# Service Bulletin

Bulletin No.: PI1199

**Subject:** Engine Cranks But Does Not Start, Engine Cranks With Loud Backfire, Engine Will Start and Stall

**Models:** 2014 Chevrolet Silverado 1500  
2014 GMC Sierra 1500  
Equipped with 4.3L V-6 Engine — RPO LV3  
Equipped with 5.3L V-8 Engine — RPO L83

3709109

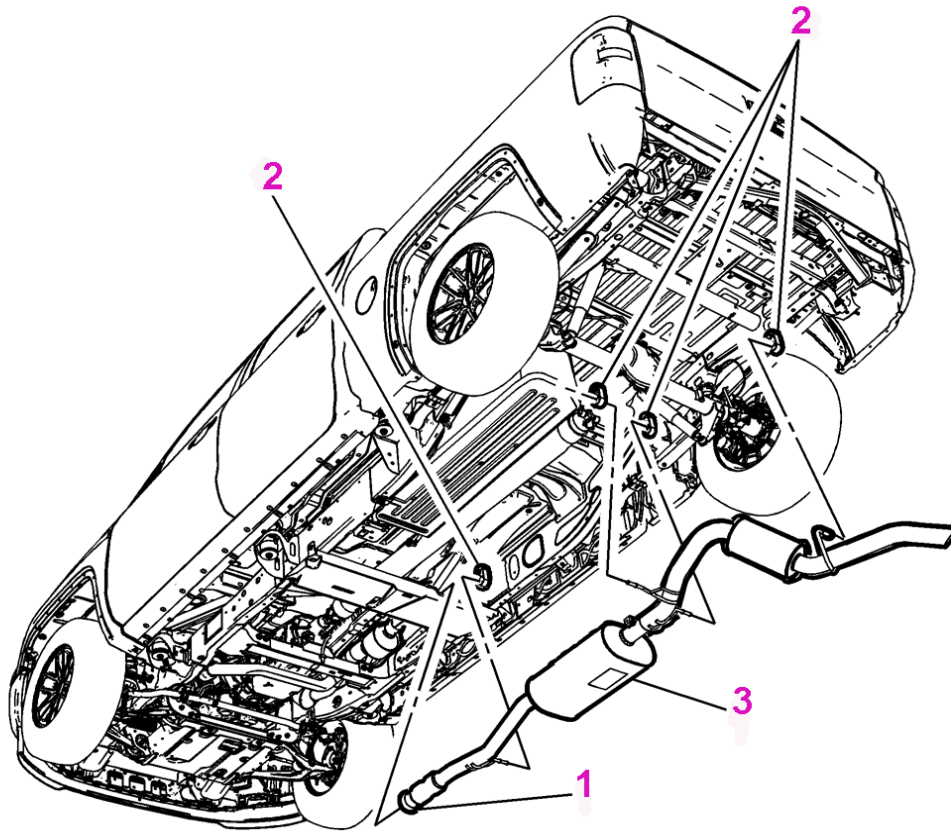
The Condition/Concern may be caused by ice buildup in the exhaust system causing the passive exhaust valve (PEV) to stick in the closed position.

3. Exhaust system part identification:
- Exhaust Muffler Clamp Fastener (1)
  - Exhaust Muffler Isolators (2)
  - Exhaust Muffler (3)

4. Replace the exhaust system. Refer to: Exhaust Muffler with Resonator, Exhaust, and Tail Pipe Replacement in SI.
